RE: Lil'wat Main Street Development – Zoning Amendment Bylaw 1697-2020 and OCP Amendment Bylaw 1698-2020 – Referral

The PVDD has reviewed the proposed development and has the following comments.

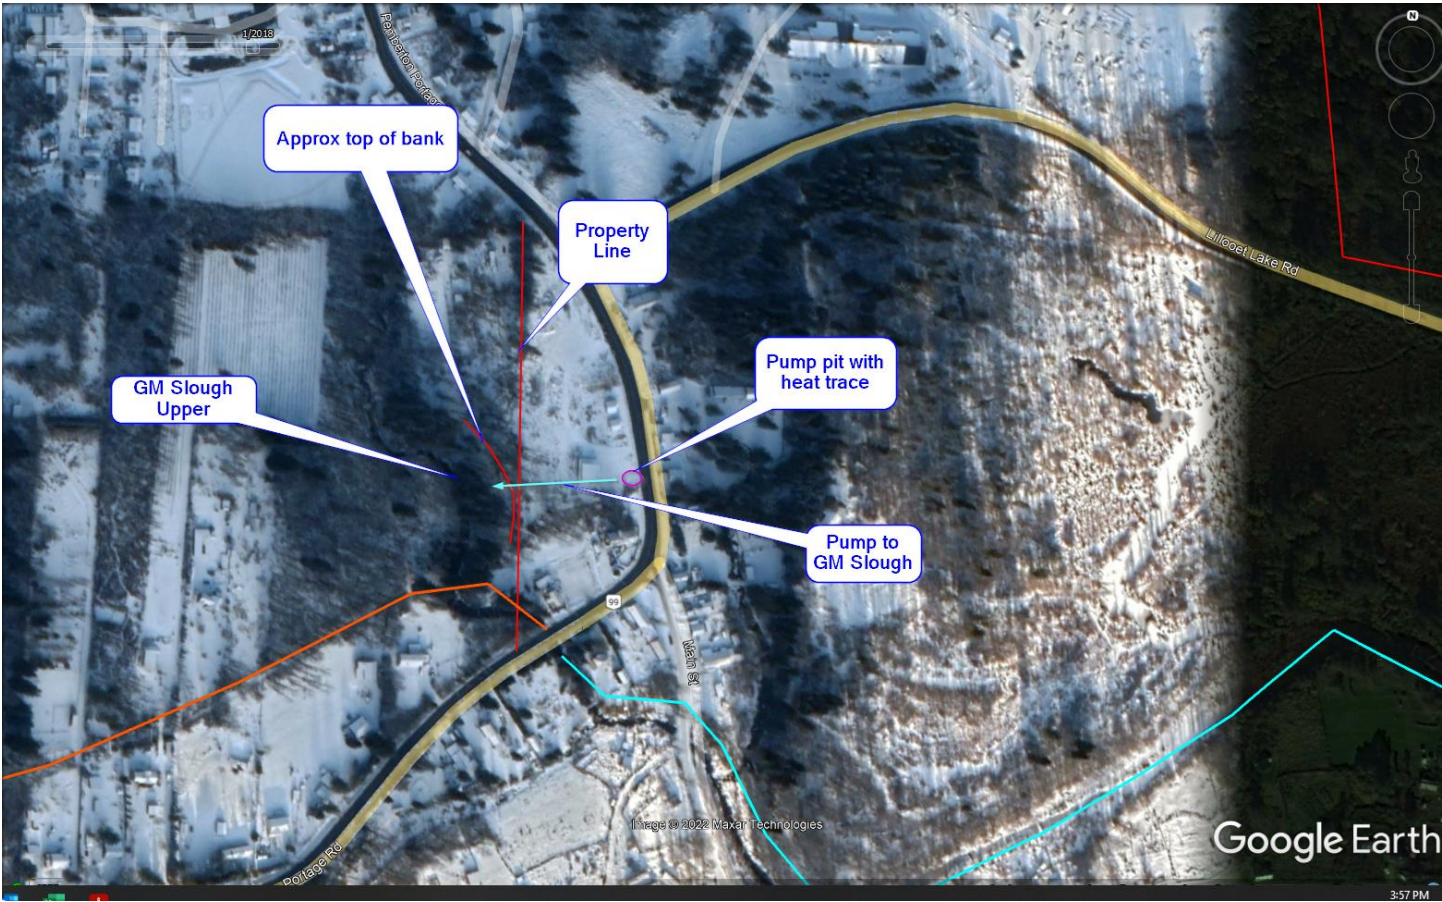
In looking at the plan for this development the parking area is not well suited for snow removal and there is no area dedicated for snow storage. Further to this the proposed highway ditch states, "should not be used for snow storage" The reality is that this area will likely fill up with snow from the clearing of the highway itself and not just from the clearing of snow from the development. This is a problem that should be solved up front.
